INDIANA DEPARTMENT OF TRANSPORTATION

APPROVED MINUTES

September 17, 2009 Standards Committee Meeting

SPECIFICATION REVISIONS
REVISION TO THE STANDARD DRAWINGS

714-CCSP-03 THREE SIDED CONCRETE CULVERT SCOUR PROTECTION
 (REVISED DRAFT)

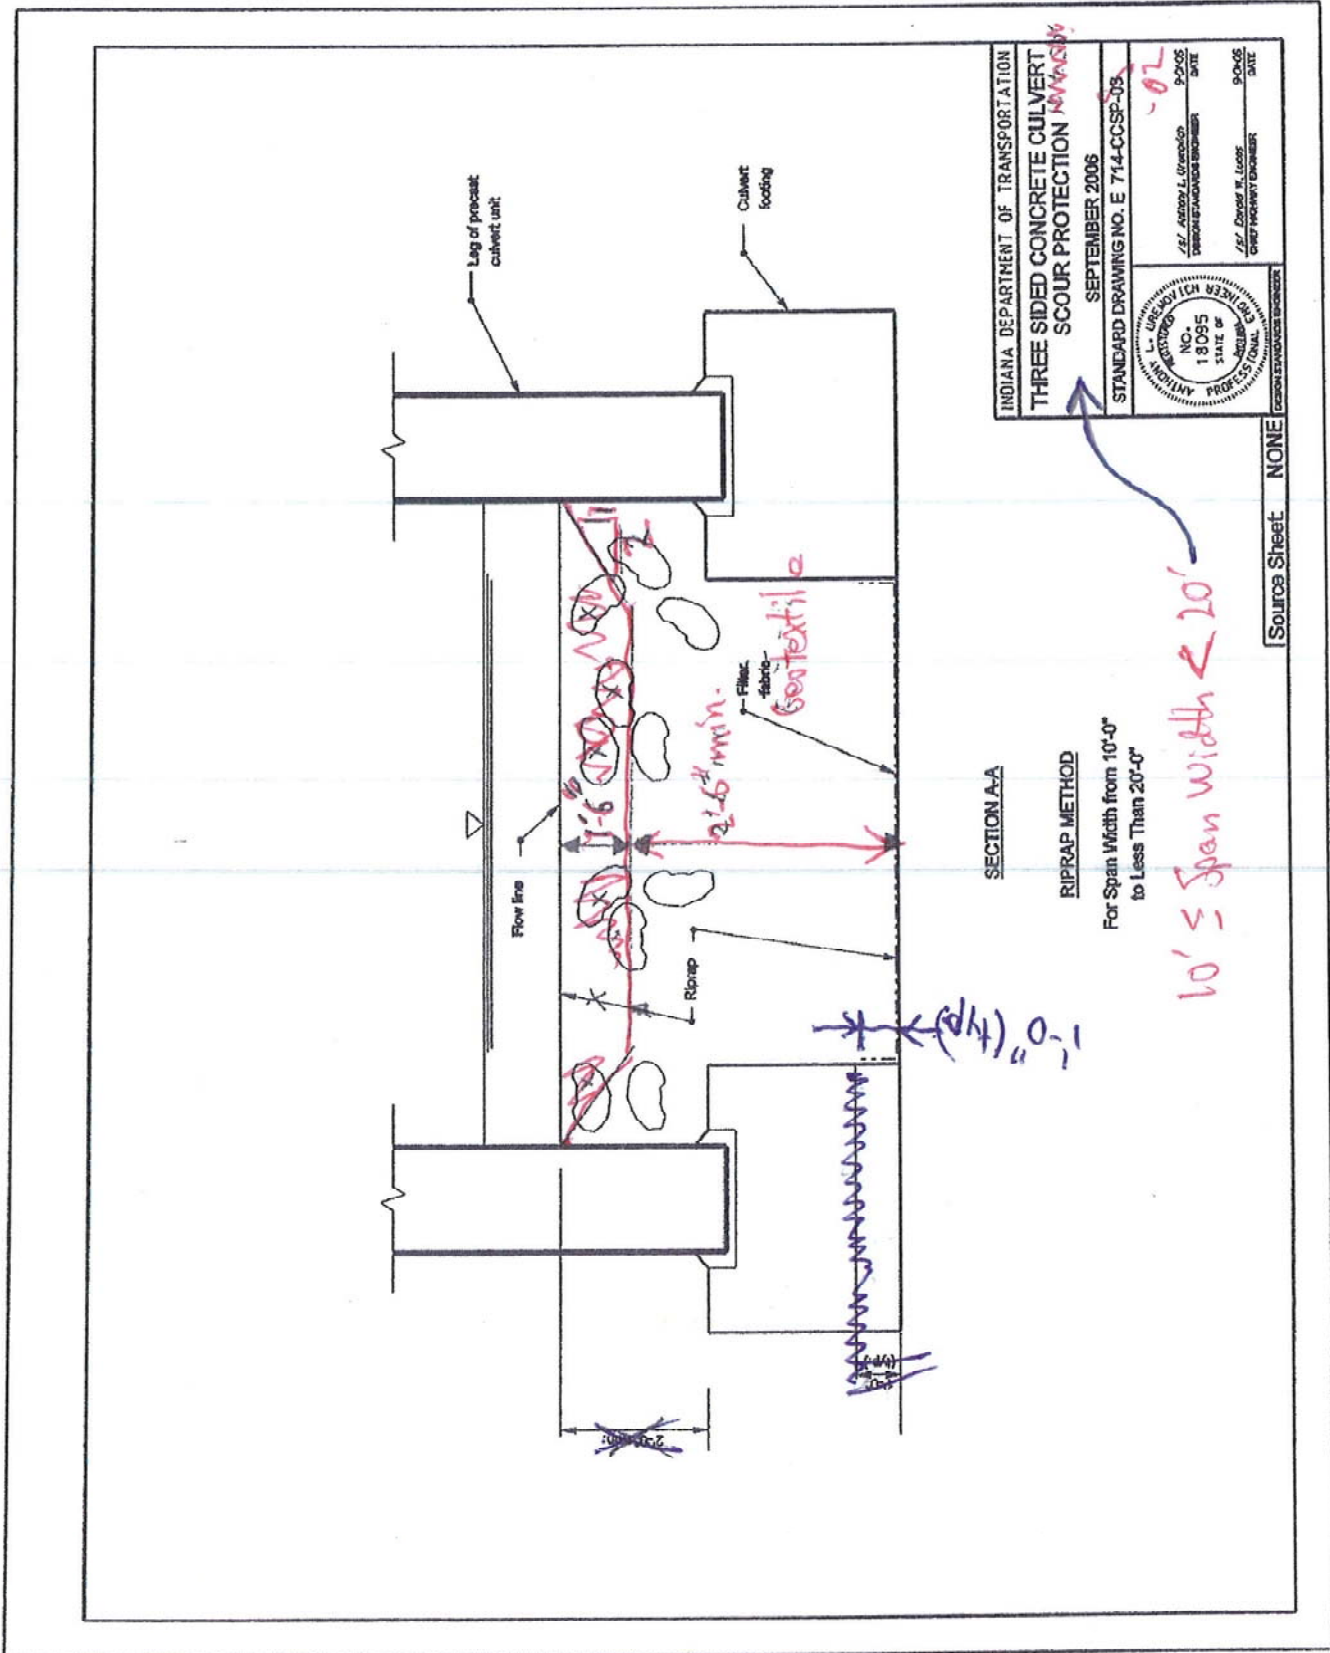
PROPOSED SOLUTION: Revise the Standard Drawings for three-sided-culvert scour protection to allow for passage of natural stream-bed material as required by IDEM. Standard Drawings 714-CCSP-01 through -05 are affected, with a new drawing added. The CCSP series will be numbered as follows:

DISCUSSION: Mr. Uremovich distributed revised draft standard drawings for committee consideration—the CCSP series now includes six sheets. The additional changes included in the handout were marked in purple. Mr. Caplinger noted another slope revision is required on sheet 01. Mr. Keefer and Mr. Pankow were concerned regarding the required foundation excavation width being wider than necessary, although they acknowledged that the riprap requirement may be the reason. Mr. Heustis commented that sheet 04 should account for situations where the foundation could be excavated nearly vertically as would be the case for a tight clay. This would revise the quantity of riprap required. Mr. Heustis suggested that the riprap measurement and payment could be based on a neat line basis.

ACTION: The standard drawings should be revised per the comments made at the meeting and updated electronically to present at a future meeting.

715-PCSP-01 PIPE CULVERT SUMPING PROTECTION (CONTINUED)
(REVISED DRAFT)

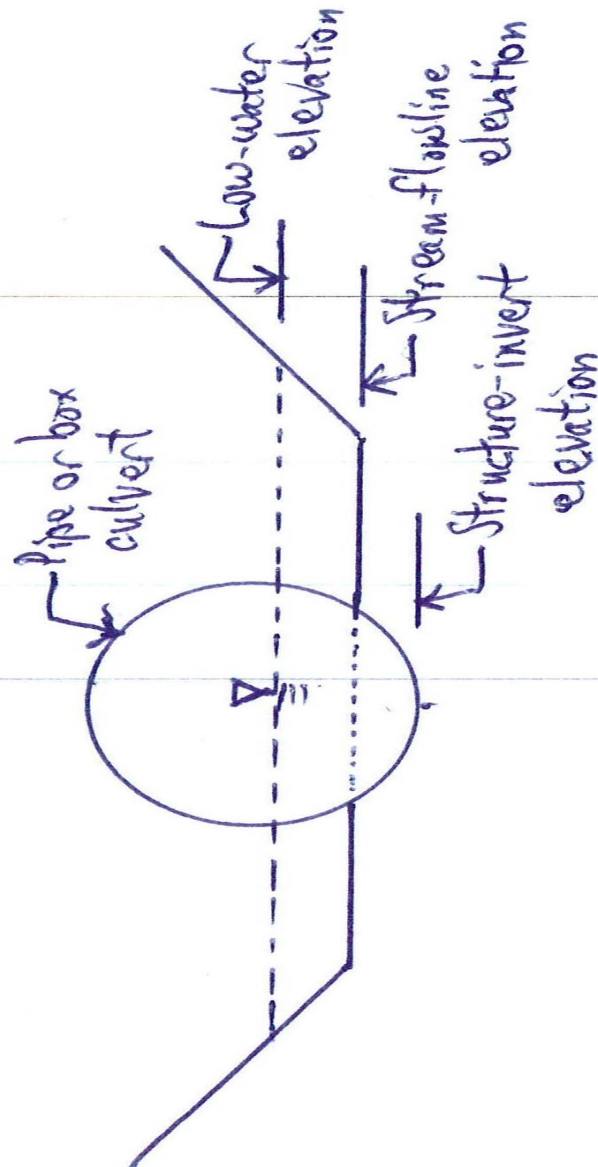
New drawing 715-PCSP-01 is added to show the sump treatment for a pipe culvert.

Mr. Pankow indicated that revisions to 715 may be required to address pipe cleaning.
